# **Olmsted County Planning Department**

# **Oronoco Township Planning Advisory Commission**

- Request:Oronoco Township General Development Plan #OR2022-001GDP by E &<br/>K Boelter Trust c/o Tom Boelter. The request is for a general development<br/>plan for Boelter Heights which includes 29 single-family residential lots.
- Location: The property is located in the W 1/2 of the NE 1/4, Section 34 of Oronoco Township. The property lies East of 18th Ave (County State Aid Highway 112) and West of 11 Ave NW; it is south of 85th St NW and North of Cedar Ridge Subdivision.

The applicant is requesting approval of the	Planning staff recommends approving the
general development plan for Boelter Heights	general development plan for Boelter Heights
which consists of 29 single-family residential	to include 29 single-family residential lots on
lots on 79 acres.	79 acres with 6 conditions.

213570 GDP.dwg

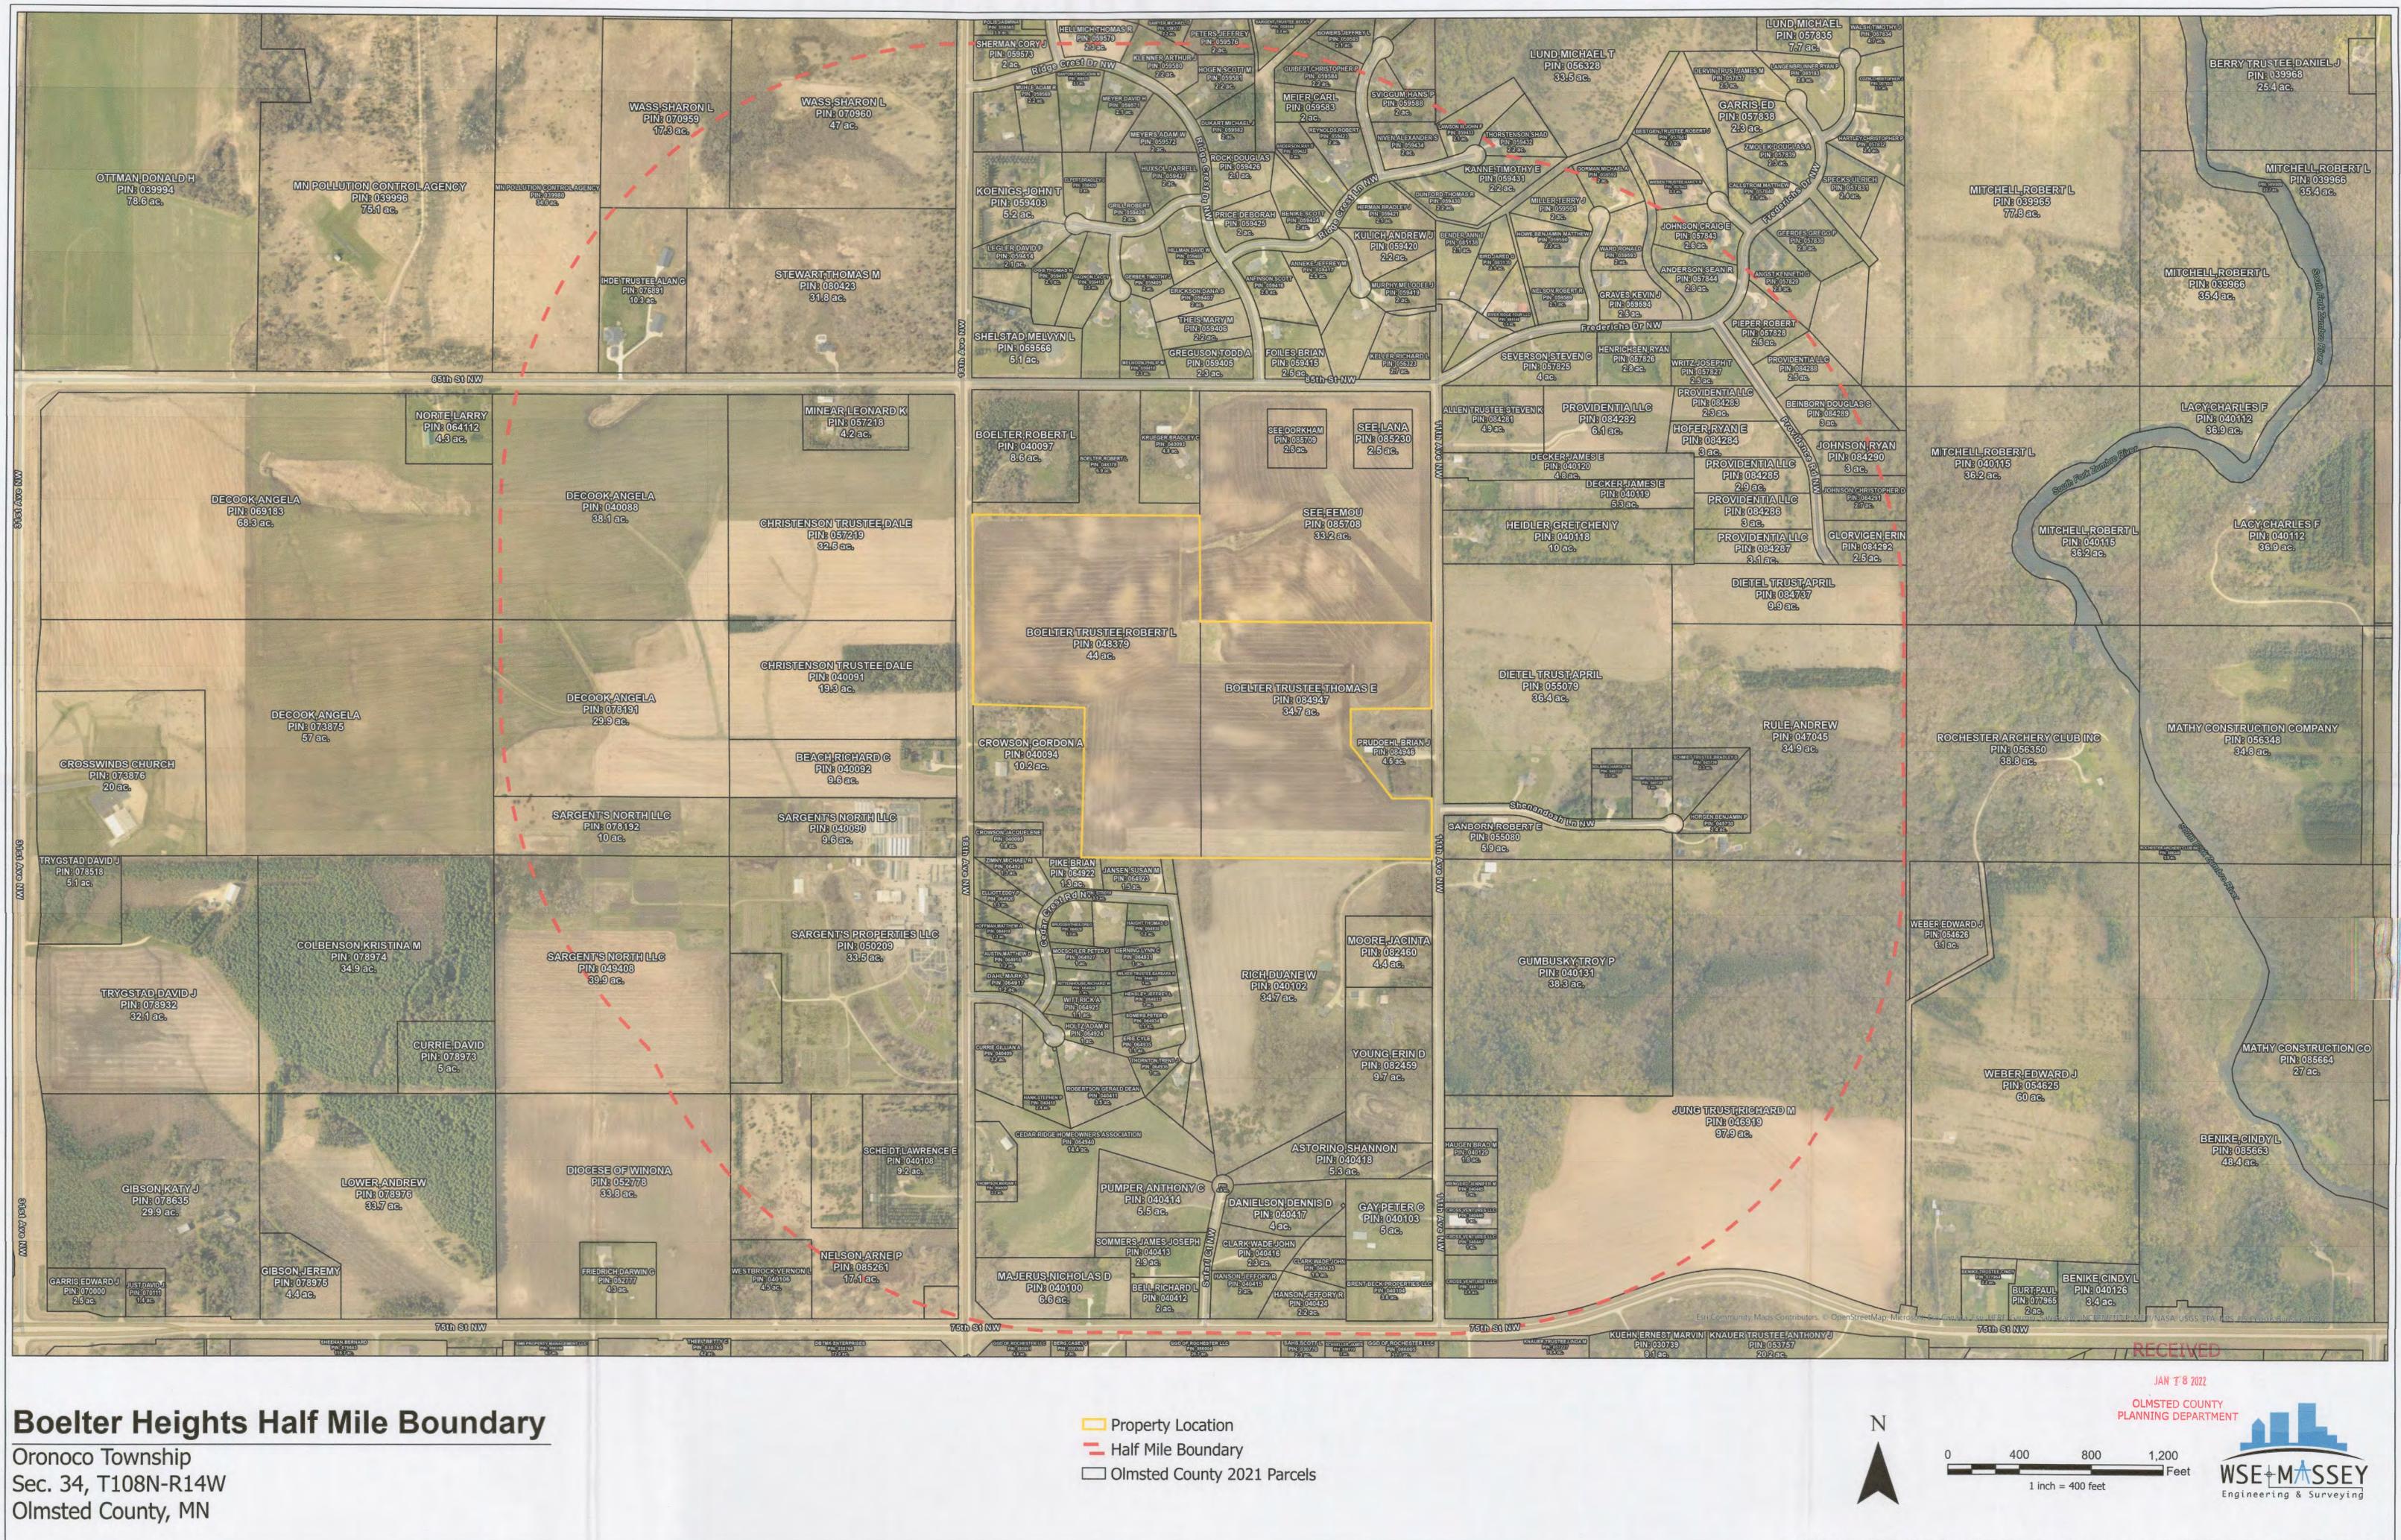
- b. Transportation and other infrastructure systems internal to the planning area, including the street pattern and connection to external street network and shared water supply and sewage treatment systems: The proposed GDP shows a local street connecting 11<sup>th</sup> Ave NW to 18<sup>th</sup> Ave NW. There are 3 cul-de-sacs spurring from the through street. The narrative indicates there will be shared wells and individual septic systems. The GDP shows an easement for a future road connection to the property to the northeast. There was a connection to Boelter Heights provided by the development to the south (Cedar Ridge Subdivision). Boelter Land Trust owns the connection point from Cedar Crest Lane. This GDP does not propose to use this available access point. However, the roads within the Cedar Ridge Subdivision are private. If a connection was made, it could provide a secondary exit for the lots to the south, other options exist for a secondary access to Cedar Ridge Subdivision, if one is needed in the future. The township supports the request to not make a connection to the Cedar Ridge Subdivision (incorrectly referenced by the applicant as Safari Estates).

- c. The surface water drainage system: **Contours are provided on the GDP and three areas are identified as drainage easements for stormwater facilities.**

- d. The open space system that may include natural resource lands: **There is no open space shown on the GDP. The area on the GDP that is highlighted yellow is the location of the floodplain soils. Further study, and a conditional use permit will be required if road, driveways or dwellings will be located in this area.**

- e. The schedule for development of infrastructure: There is a phasing plan highlighted on the GDP. Phase 1 shows 12 lots beginning on the west side of the property. The second phase is another 12 lots. The final phase will make the connection to 11<sup>th</sup> Avenue and consists of 5 lots. Below is the process for the request (the highlighted numbers are the current steps in the process):

- 9. The development layout is consistent with all provisions of the floodplain regulations within the zoning and subdivision ordinance: There are floodplain soils on the GDP that have not been addressed but must be addressed prior to the preliminary plat.

An access permit application is required for the shown access on County Road 112 (18th Ave NW) that includes the design of the right turn and bypass lane. Access control should be dedicated along the frontage of County Road 112, with the exception of the access opening.

The subdivision shall provide for interconnectivity of subdivisions. At a minimum, a public street connection shall be made to Cedar Crest Ln NW

- 1. A Conditional Use Permit must be approved by Oronoco Township in conformance with Section 9.08 of the Oronoco Township Zoning Ordinance prior to the preliminary plat for the development within the floodplain soils.
- 2. Must provide 10 feet of additional ROW in the Preliminary and Final Plat as required by Olmsted County Public works.
- 3. Must receive an approved access permit from Olmsted County Public Works prior to construction of access road to CR112.
- 4. CR 112 must be updated as required by Olmsted County Public Works to correct safety deficiencies in accordance with the access permit.

- 5. Phasing must begin at CR 112 and phase the development east towards 11 Ave NW
- 6. Erosion Control/Runoff Plan is required for the entire subdivision prior to approval of the final plat.
- 7. The preliminary plat must show controlled access along 18<sup>th</sup> Ave (CR 112) except for the access location approved by Olmsted County Public Works Department.
